COMMUNITY DEVELOPMENT DEPARTMENT

HEARING DATE: January 19, 2021

SUBJECT: FP-2020-0013
Apex Southeast No. 1

Final plat consisting of 77 single-family residential buildable lots, 2 commercial buildable lots and 13 common lots on 41.63 acres of land in the R-8 and C-C zoning districts.

B. Final Plat (dated: 10/30/20)

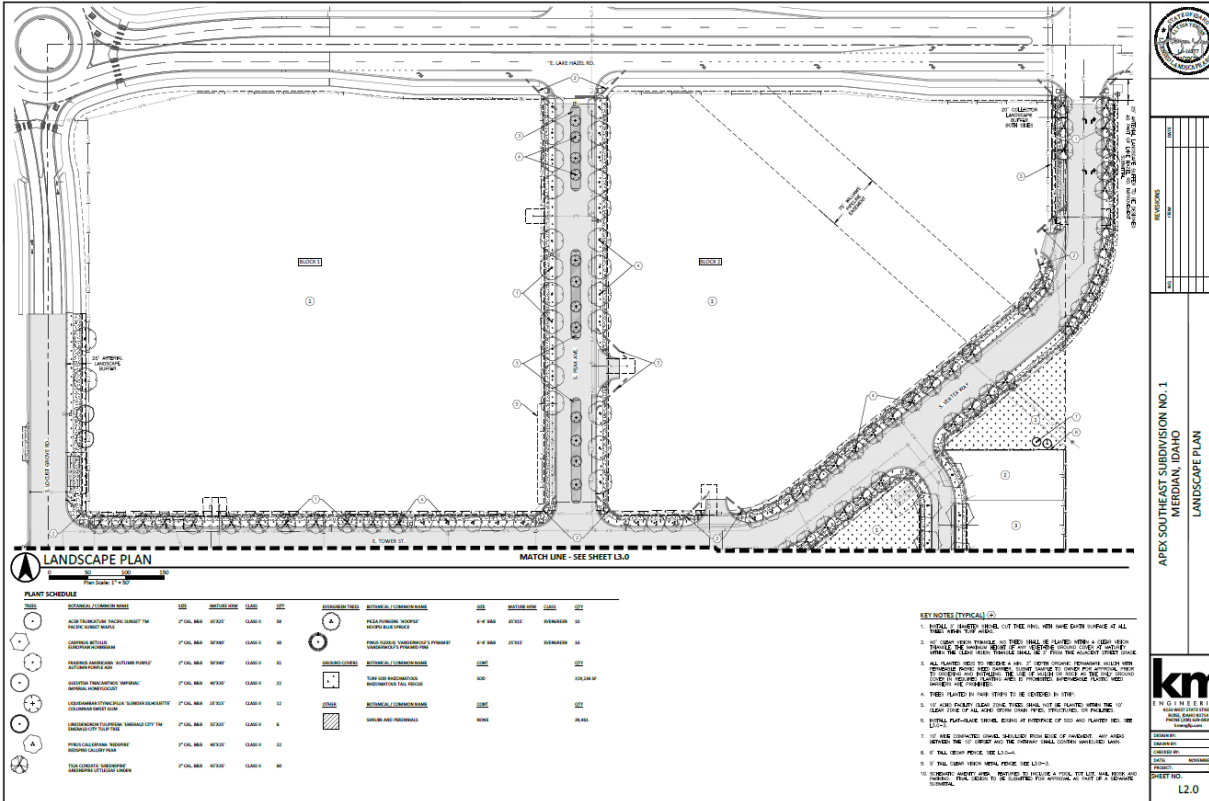
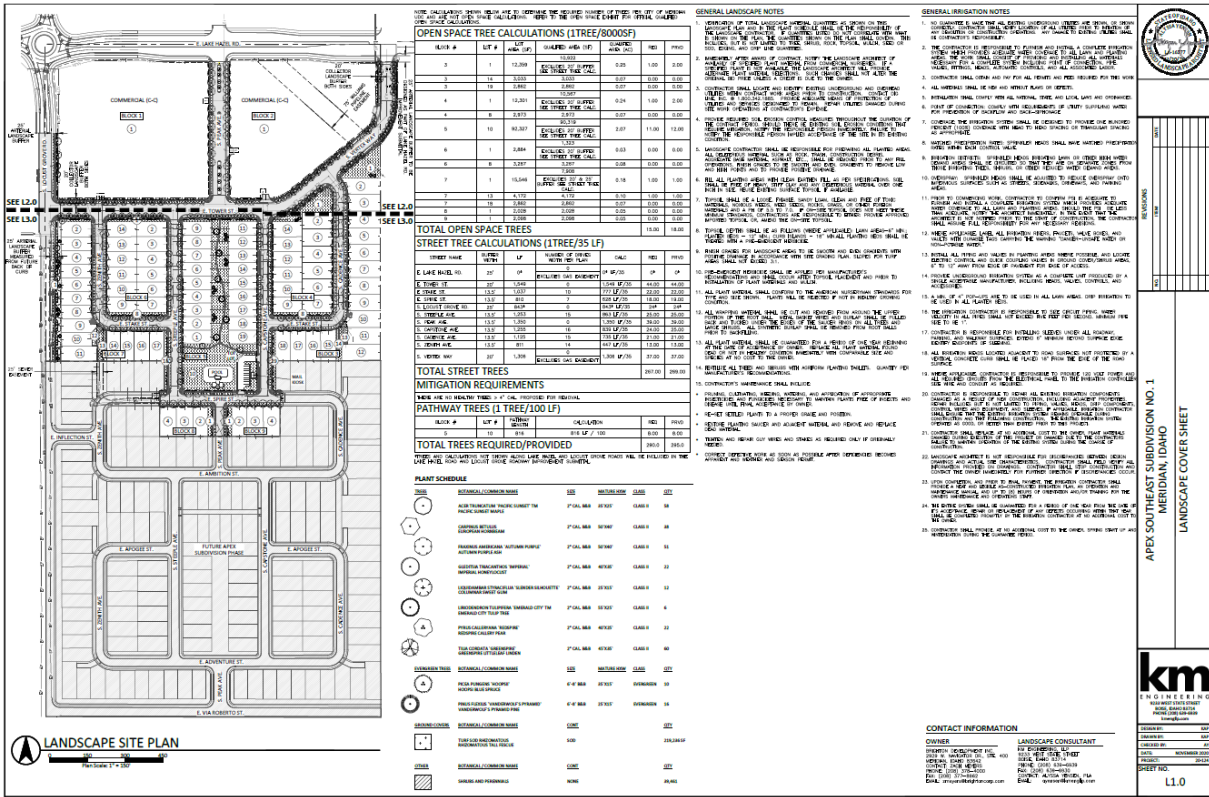
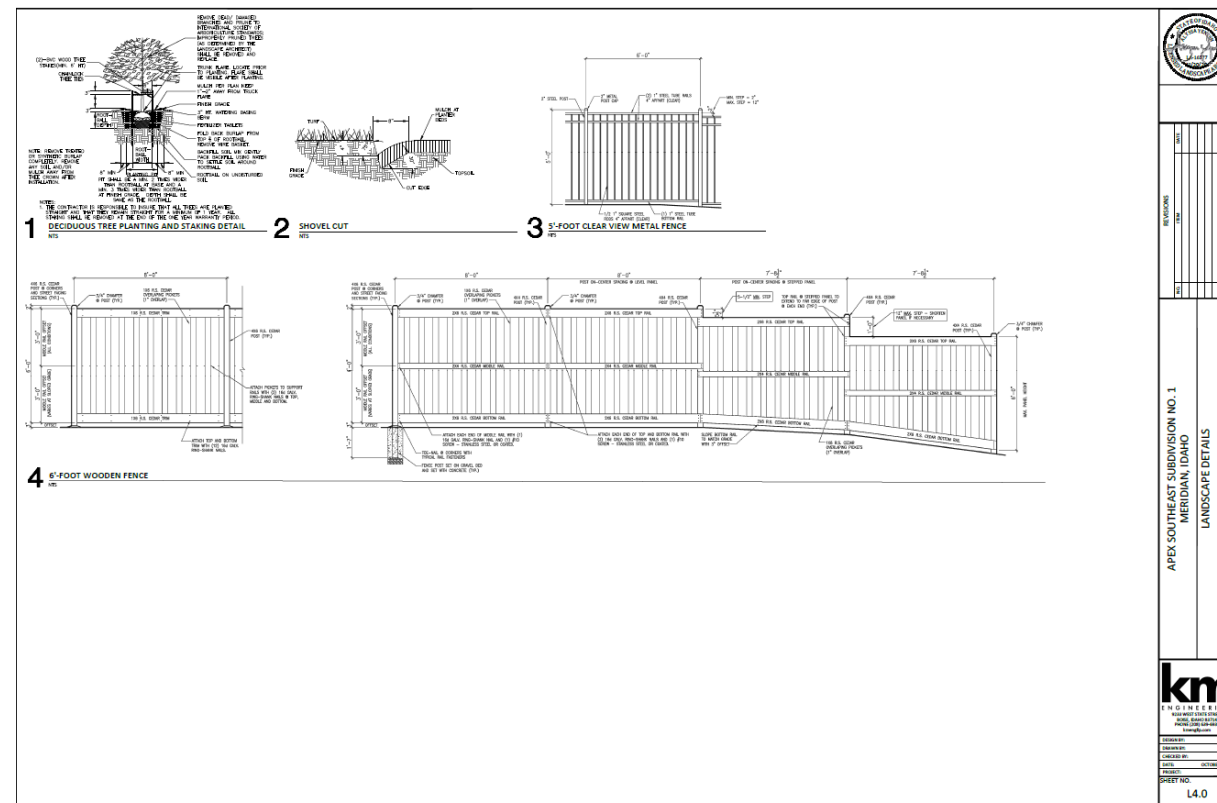
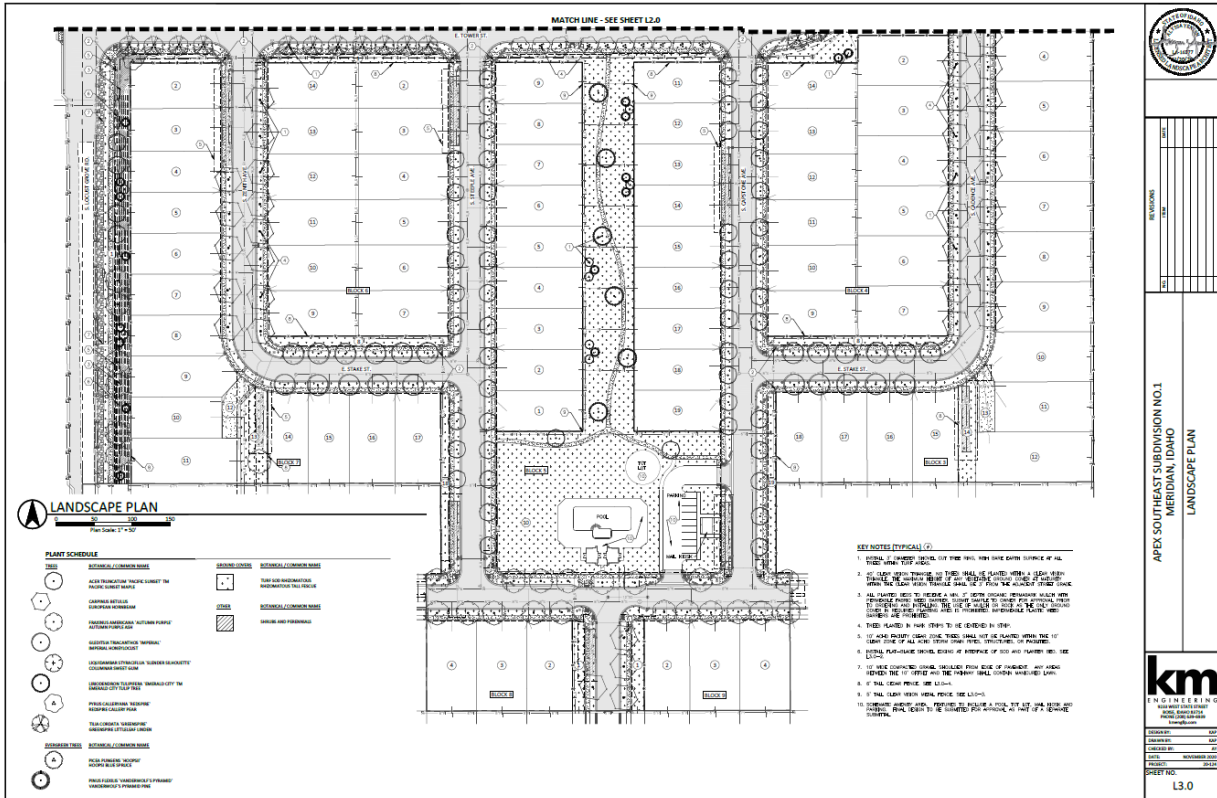
3. Prior to submittal for the City Engineer's signature, have the Certificate of Owners and the accompanying acknowledgement signed and notarized.
4. The final plat prepared by KM Engineering stamped by Aaron L. Ballard, dated: 10/30/2020, included in Section V.B shall be revised as follows:

- a. Replace S. Vertex Way with S. Bloomerang Way with change from E. Tower St. occurring at S. Cadence Ave. intersection, consistent with Ada County Street Name Review approval.

- b. Include the recorded instrument number of the City of Meridian sewer and water easement on the face of the plat on Sheets 2 and 3.
 - c. Note #5: "Lots 1, 14 and 19, Block 3, Lots ~~4 and 1~~ 1 and 8, Block 4, Lots 1 and 8, Block 6, Lots 1, 13, and 18, Block 7, Lot 1, Block 8, Lot 1, Block 9 and Lot ~~5~~ 10, Block ~~4~~ 5, are designated as common lots. . ."

- d. Note #6: "Lot 12, Block 7, and Lot 13, Block ~~13~~ are subject to a blanket easement for common drives to provide access for Lots ~~9, 10, and 11, and 13~~, Block 7, and Lots ~~10, 11, and 12, and 14~~, Block ~~13~~, respectively. Said Lot 12, Block 7 and Lot 13, Block ~~13~~ shall be owned by the Apex Southeast. . . Said Lot 12, Block 7 and Lot 13, Block ~~13~~ are subject to blanket. . ." Include a note requiring the common driveways to be constructed of a paved surface capable of supporting fire vehicles and equipment as set forth in UDC 11-6C-3D.8 in accord with preliminary plat condition #A.8.

- e. Note #13: Include recorded instrument number for ACHD landscape license agreement.
 - f. Note #14: Include recorded instrument number for ACHD public right-of-way⁷ easement (sidewalk).

- g. Note #16: Include all lots subject to the ACHD storm water drainage system easement.
 - h. Note #20: Include E. Tower St. and S. Vertex Way/S. Bloomerang Way in the note.

- i. Depict a minimum 15-foot wide common lot in Block 3 for a micro-path connection to Discovery Park in the vicinity of Lots 6 and 7, Block 3 as required by the Park's Department with the preliminary plat.

A copy of the revised plat shall be submitted with the final plat for City Engineer signature.

Emergency Access

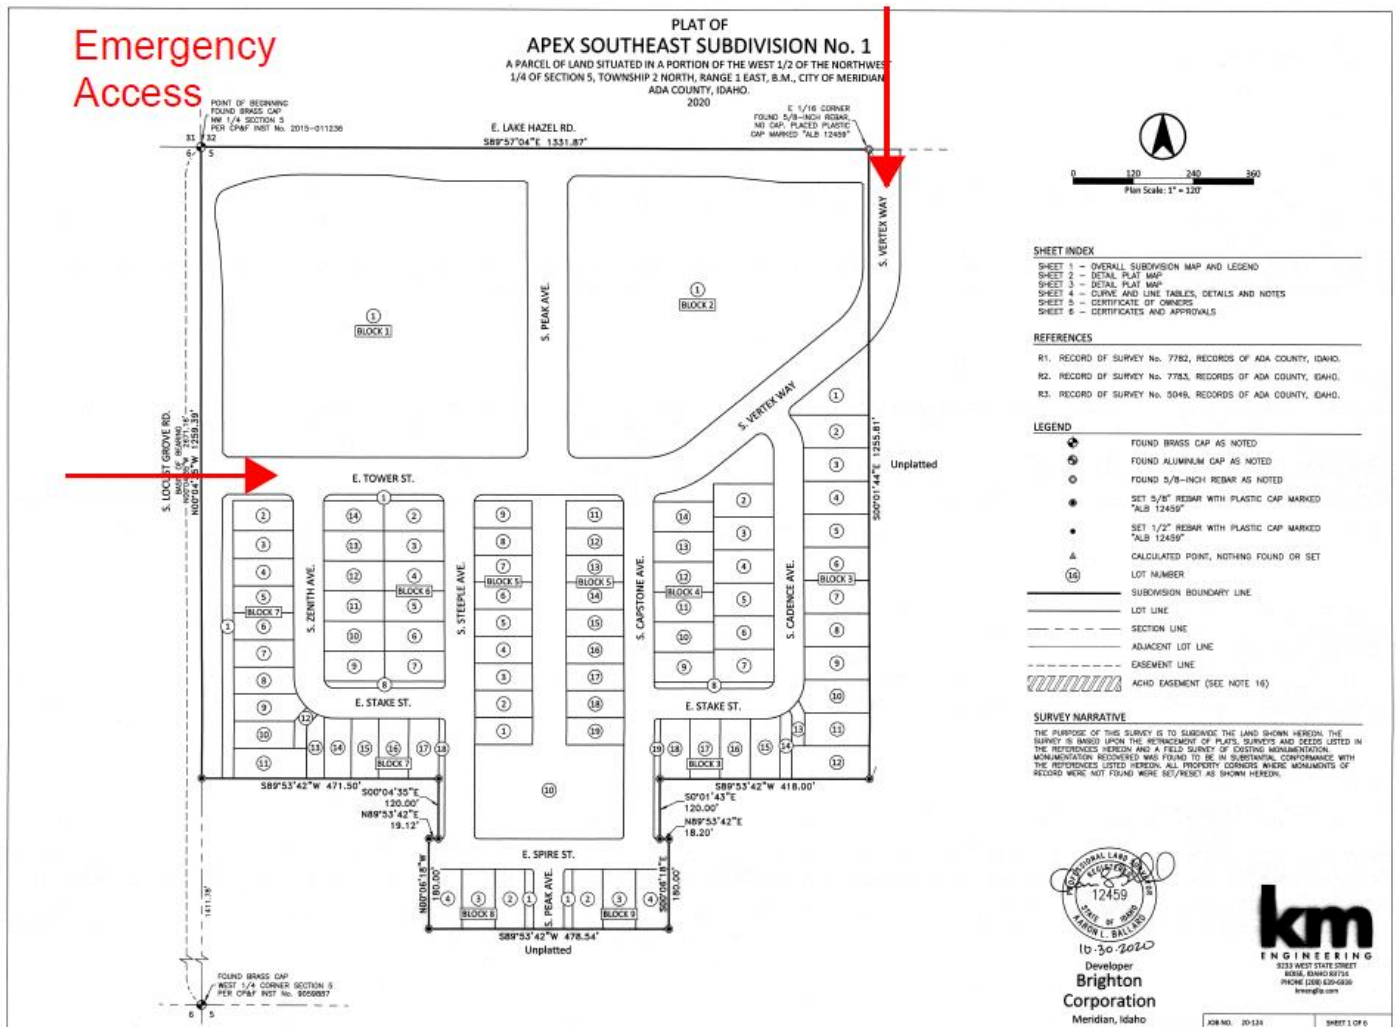
The proposed emergency access exhibit in Section VIII.F has been approved by the Fire Dept.
